Iowa Department of Transportation	REVISION
	NEW 10-19-10
STANDARD ROAD PLAN	RR-26
	SHEET 1 of 1

SUBBASE PATCHES

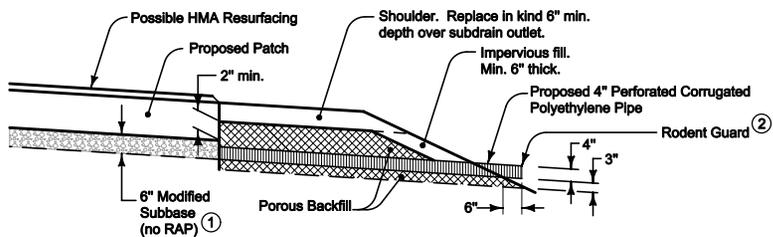
REVISIONS: New. Moved common Drain Placement Detail from RR-2 through RR-18. Modified drain size and subbase. Added rodent guard.
